# CATAWBA COUNTY BLACKBURN RESOURCE RECOVERY FACILITY TREATMENT AND PROCESSING FACILITY CONSTRUCTION DRAWINGS

**MAY 2025**  
**REV. JUNE 6, 2025**  
**REV. JULY 15, 2025**  
**REV. AUG. 5, 2025**

CONSTRUCTION DRAWINGS

**SHEET  
 1**

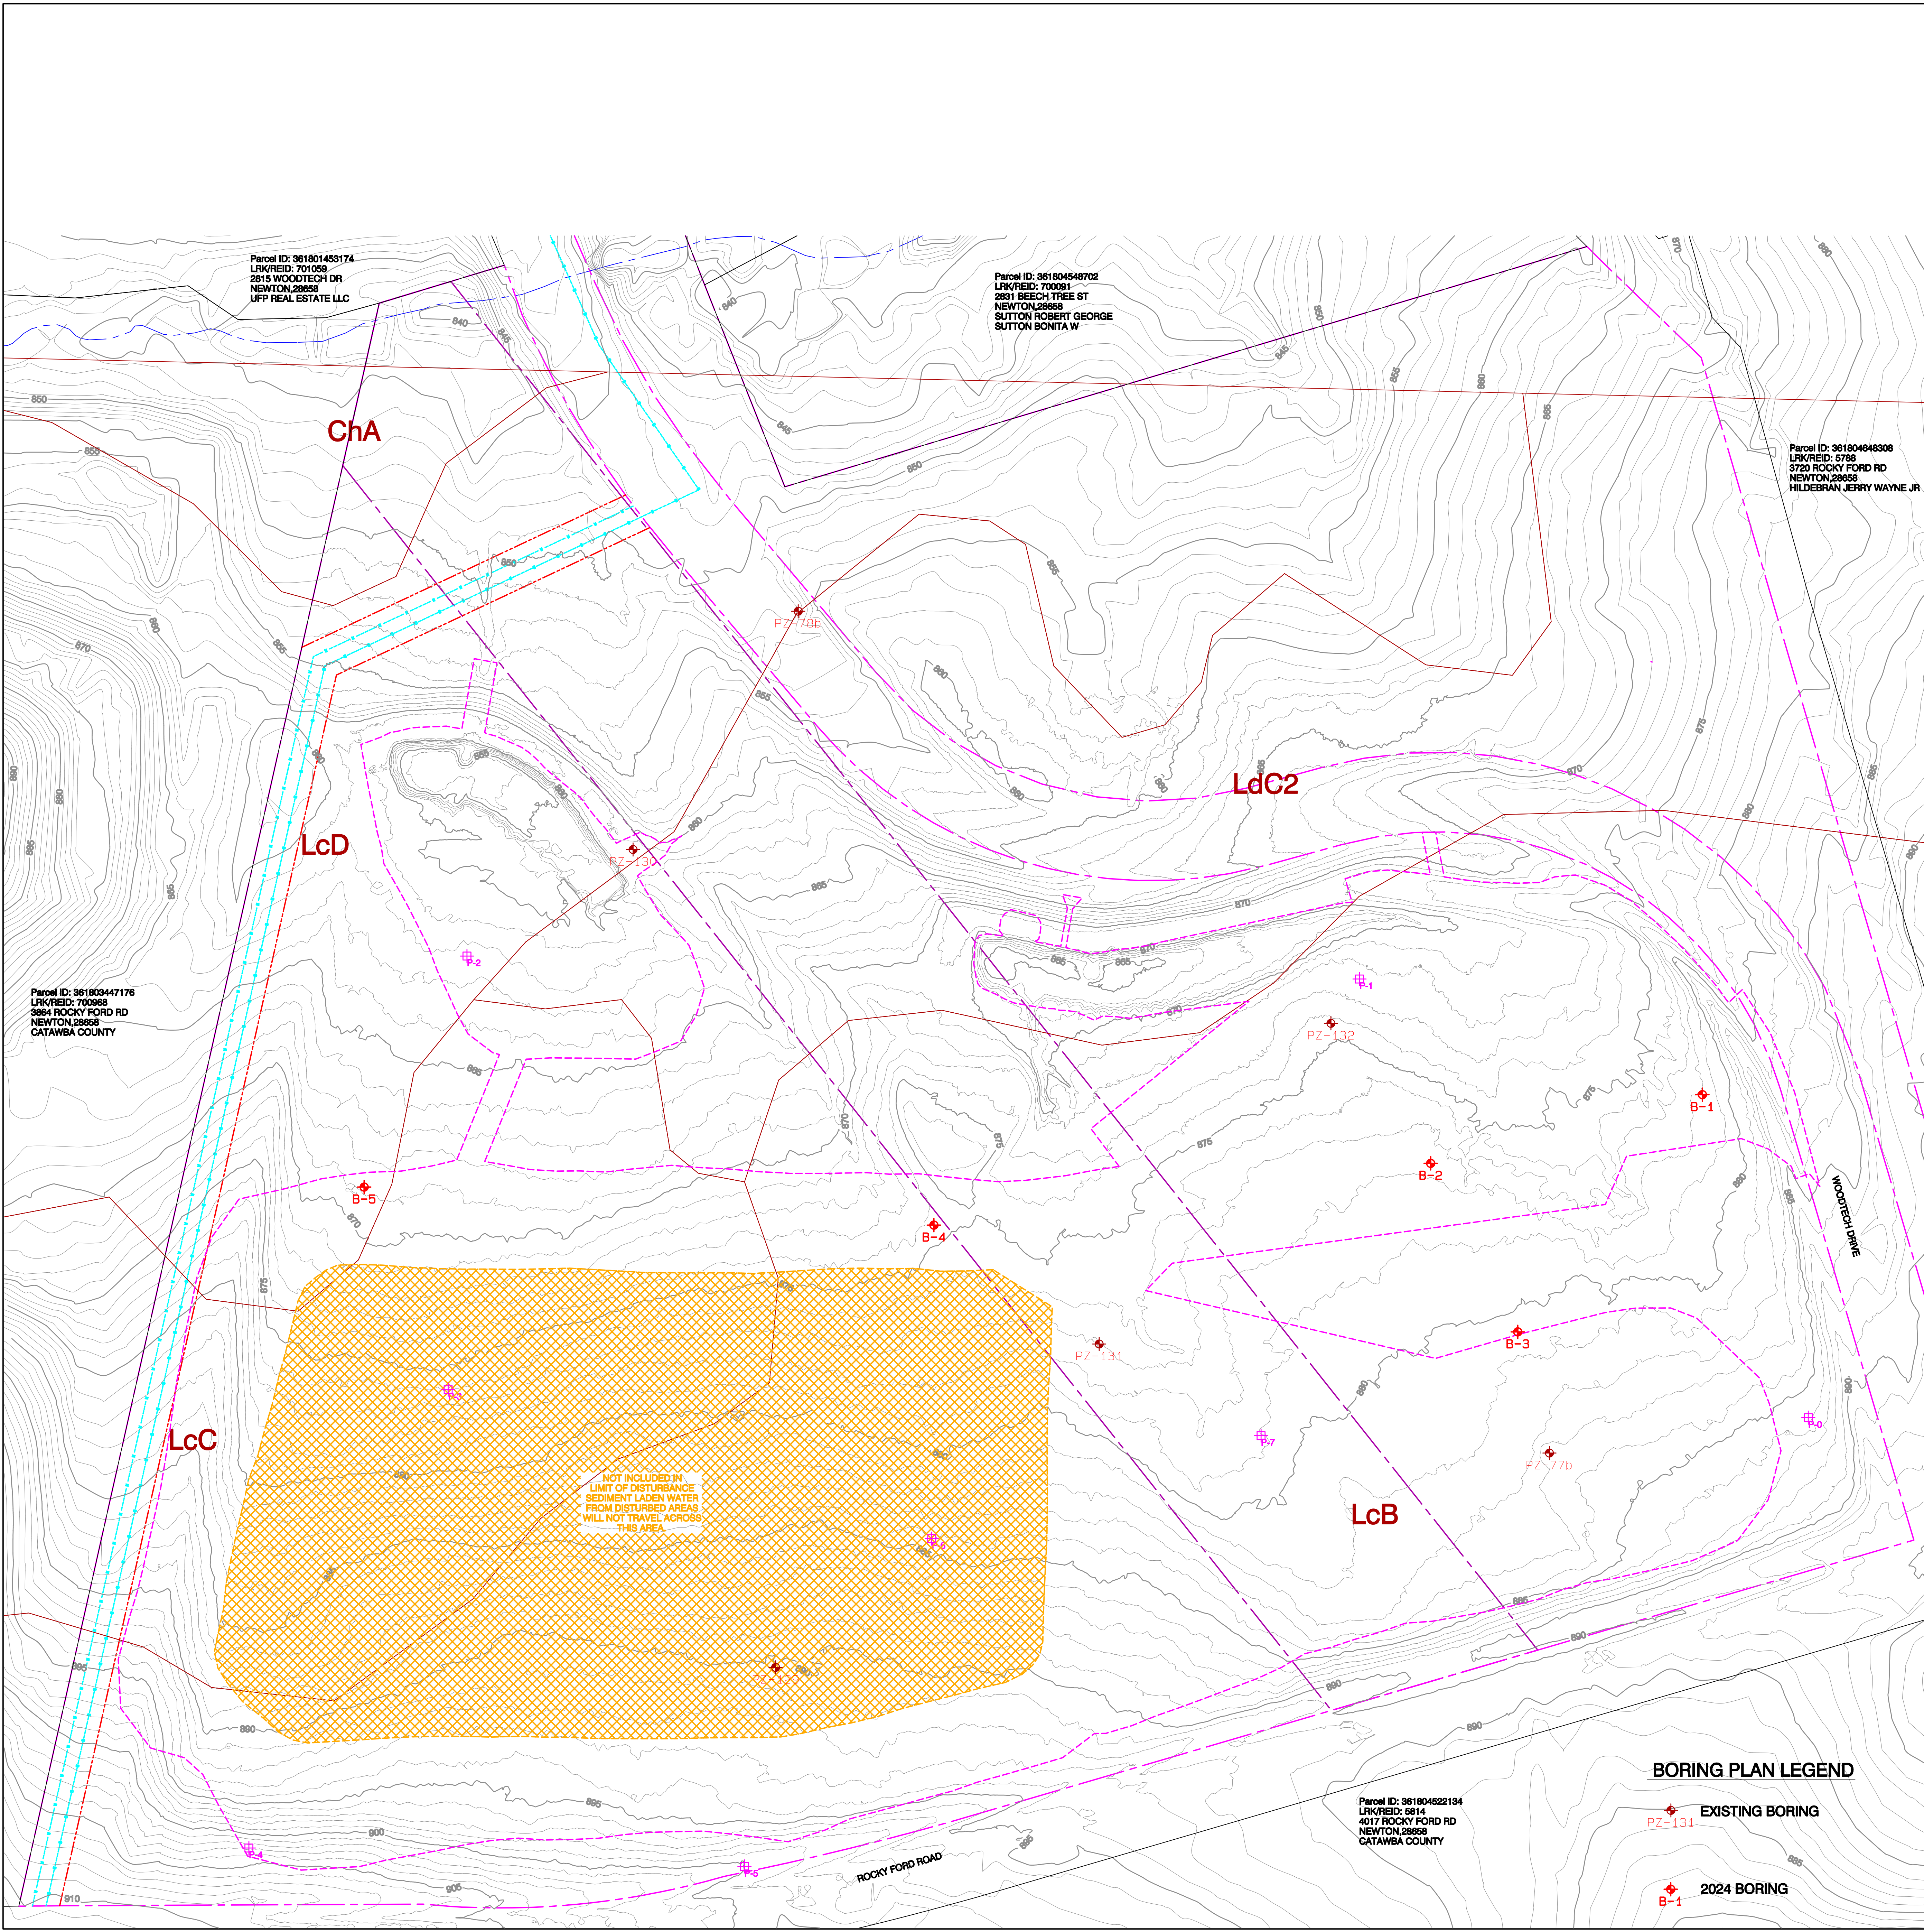
REVISED JULY 15, 2025  
 1. LIMIT OF DISTURBANCE REVISED.

**SHEET  
 2**

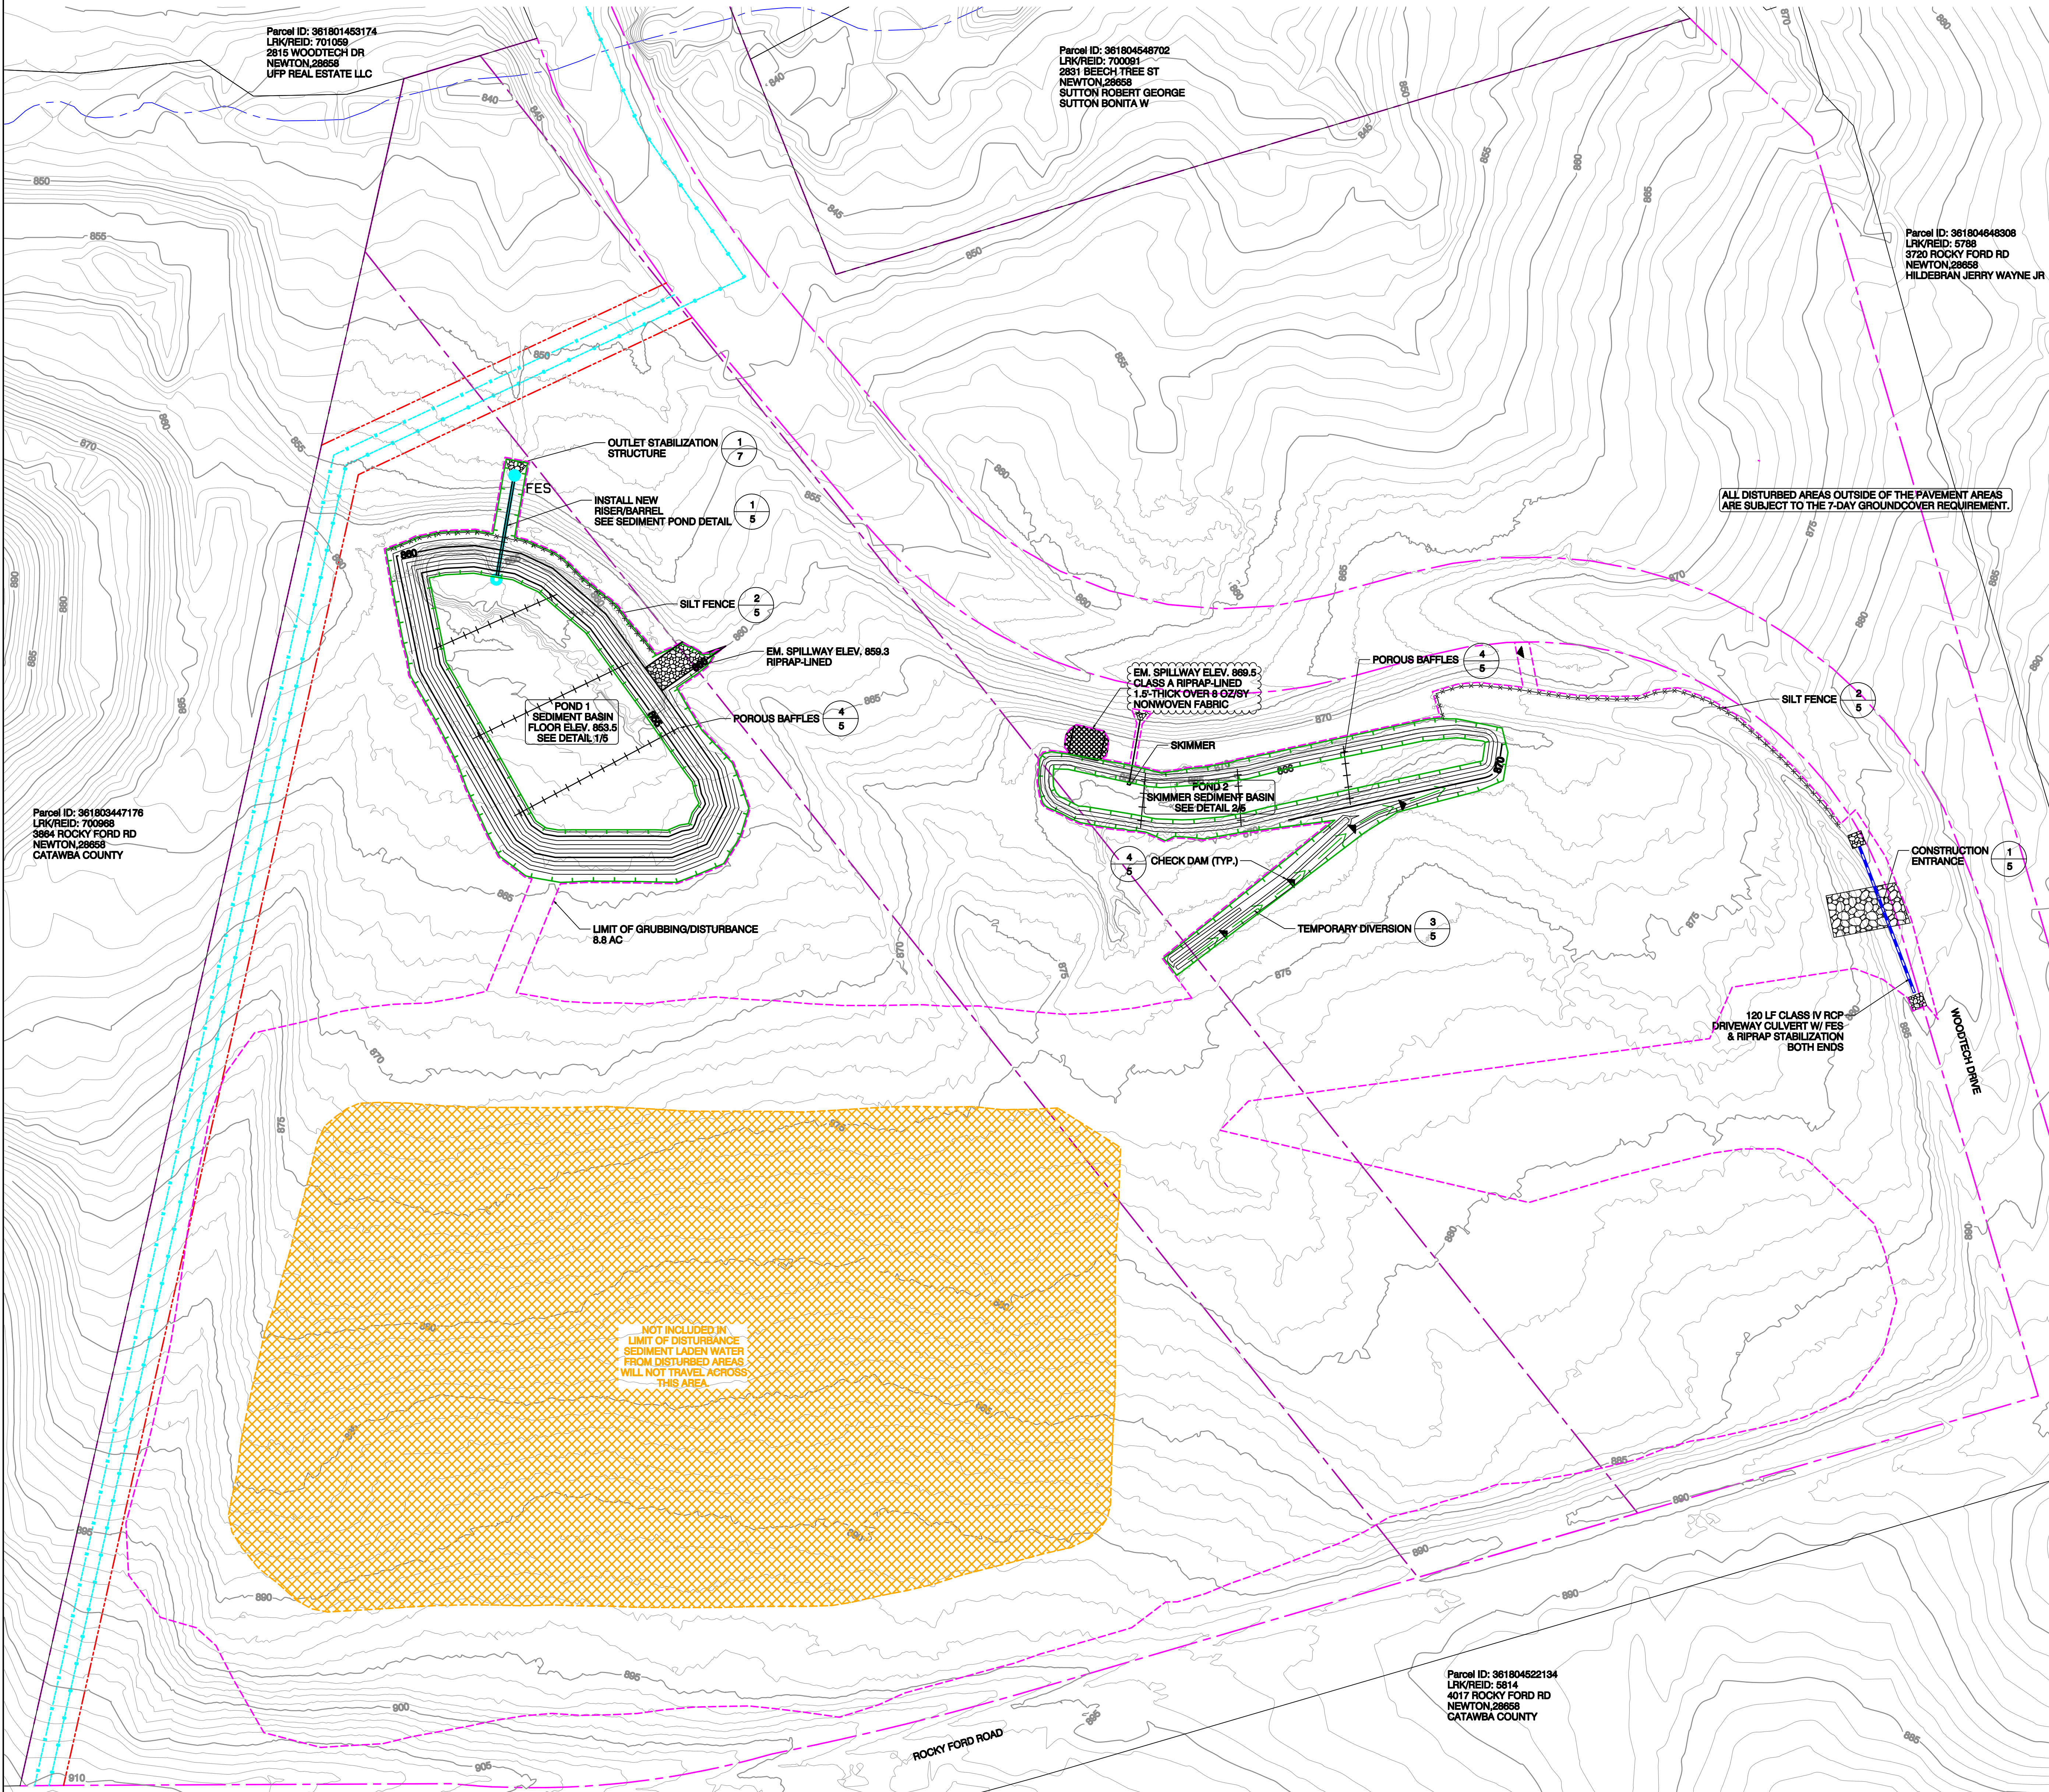
REVISED JULY 15, 2025  
 1. LIMIT OF DISTURBANCE REVISED.  
 2. POND 1 AND POND 2 REGRADED WITH FLAT BOTTOMS.

REVISED AUGUST 5, 2025  
 1. LIMIT OF DISTURBANCE FLAGGING CLARIFIED. SEE CONSTRUCTION SEQUENCE, NOTE 2.  
 2. POND 2 EMERGENCY SPILLWAY RIPRAP LINING ADDED.

**SHEET  
 3**

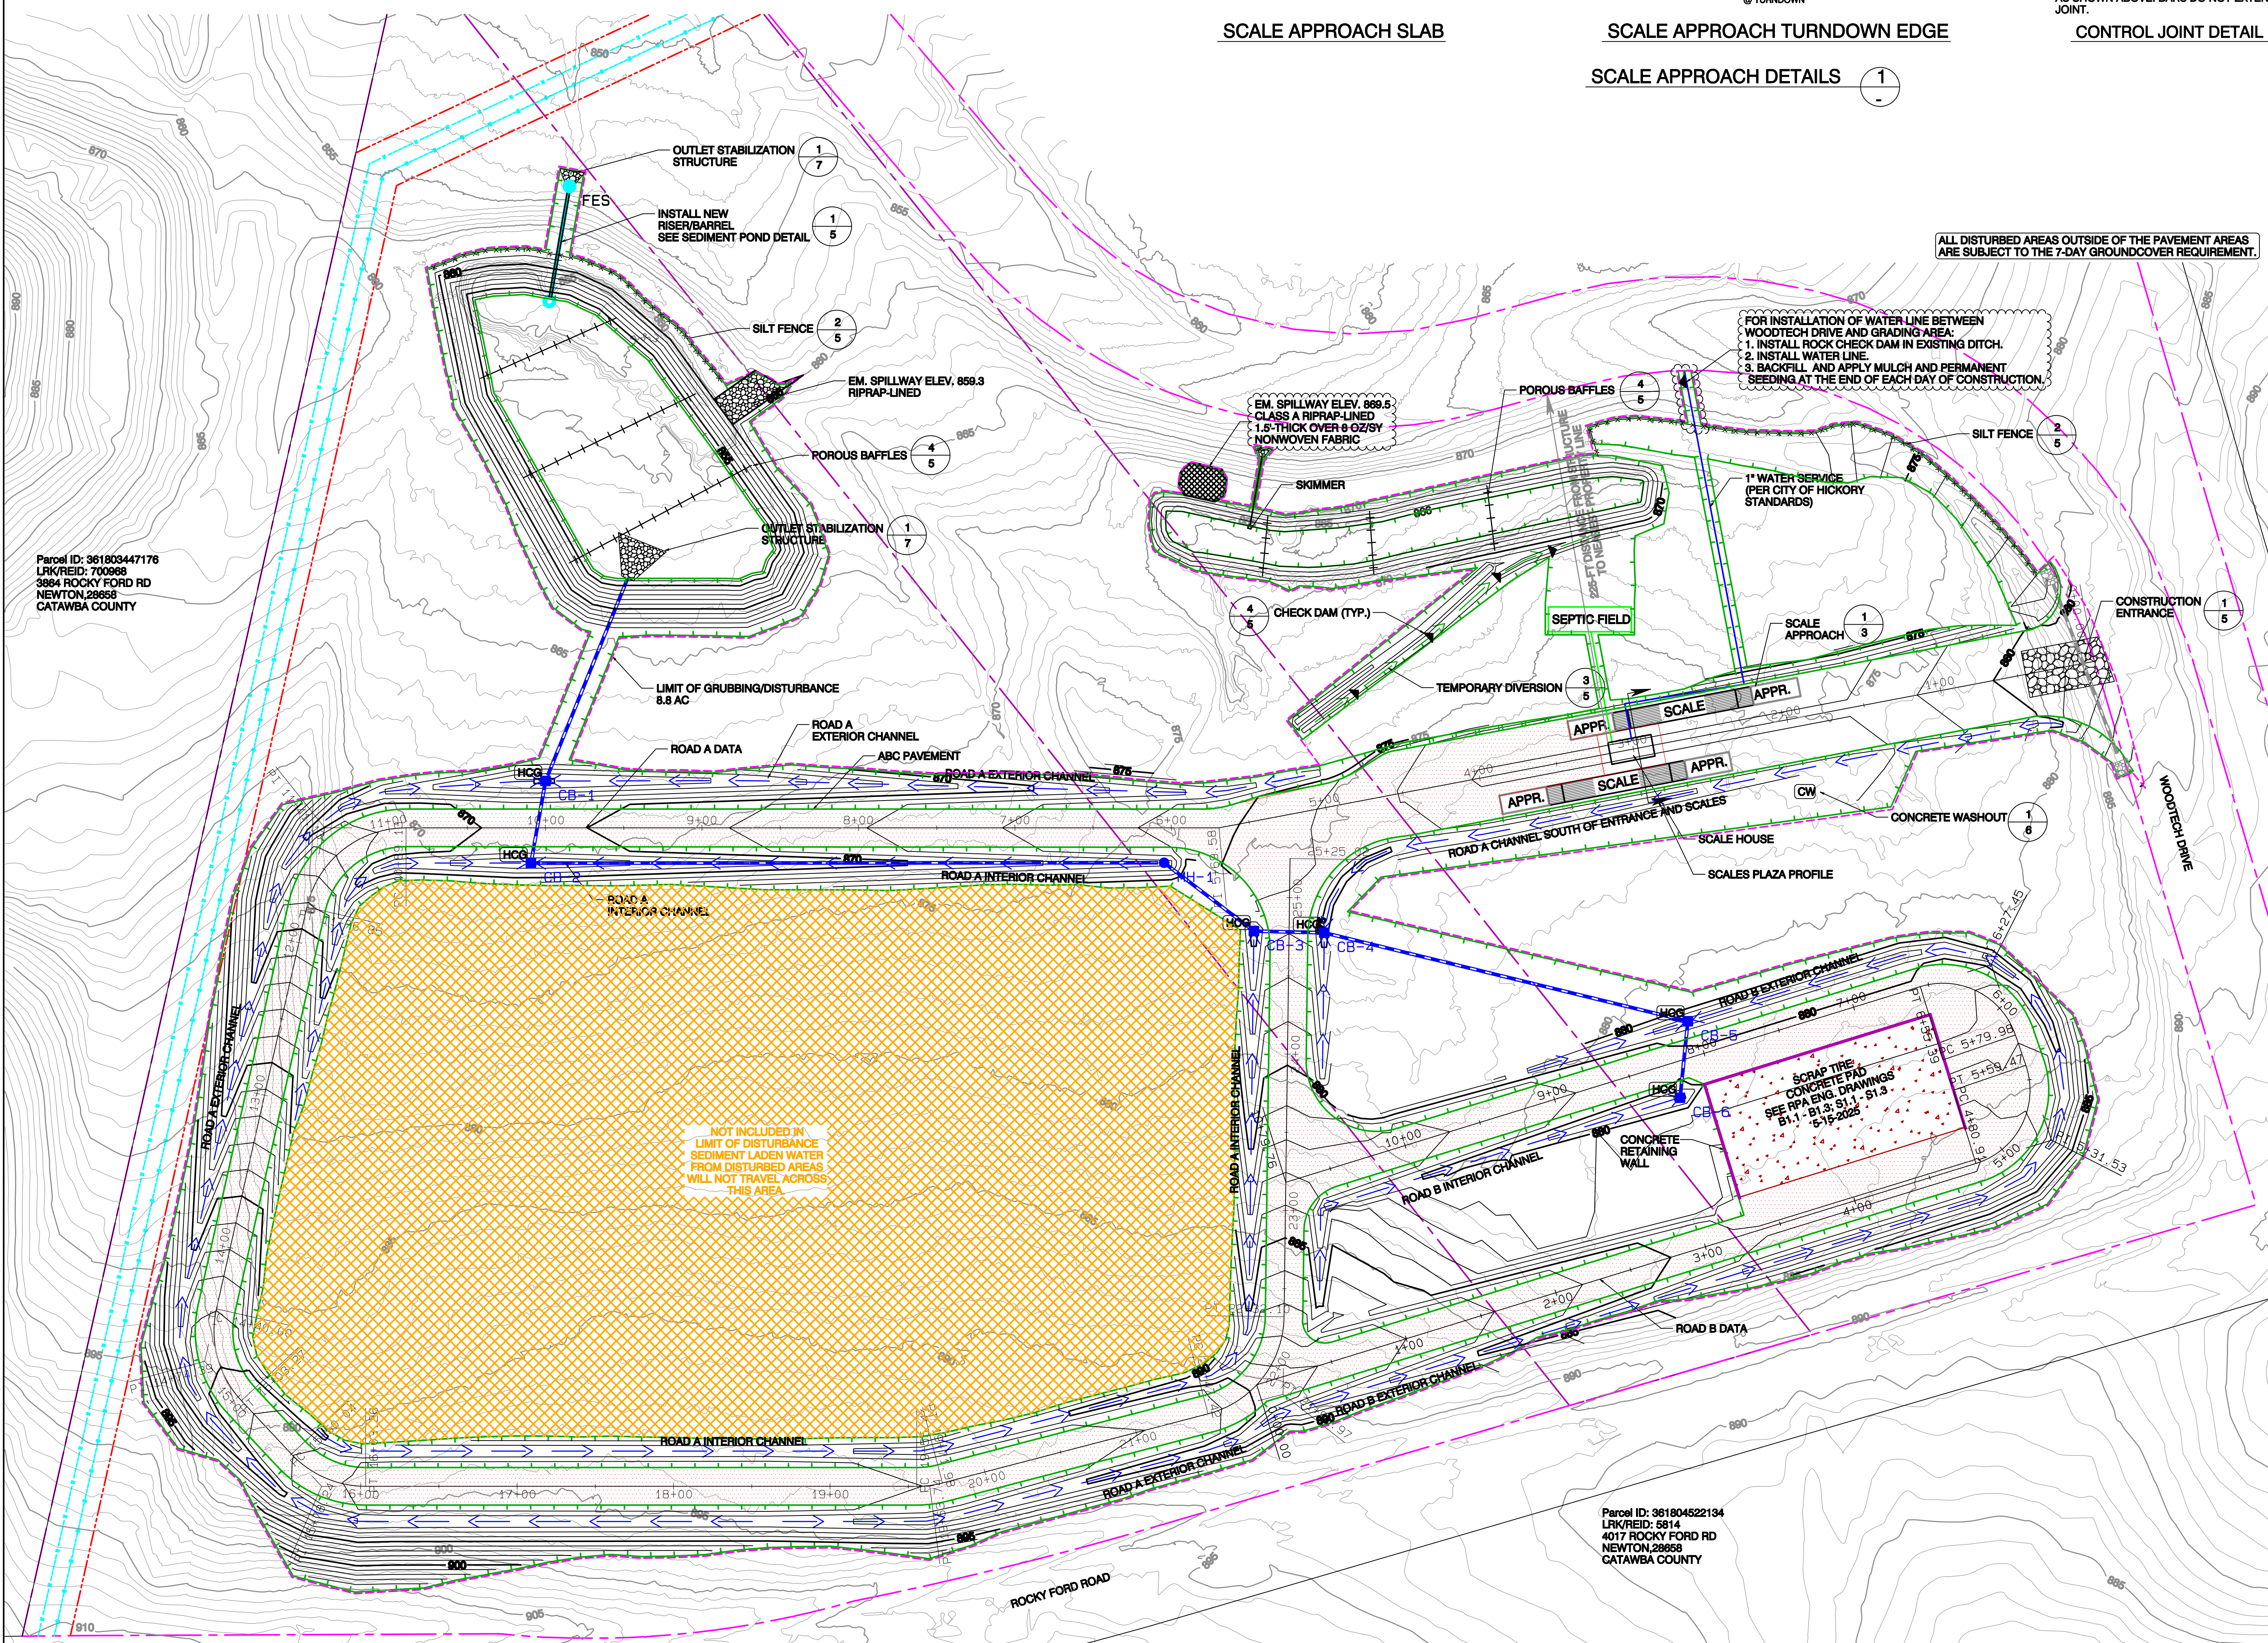
REVISED JULY 15, 2025  
 1. LIMIT OF DISTURBANCE REVISED.  
 REVISED AUGUST 5, 2025  
 1. CONSTRUCTION SEQUENCE CLARIFIED.
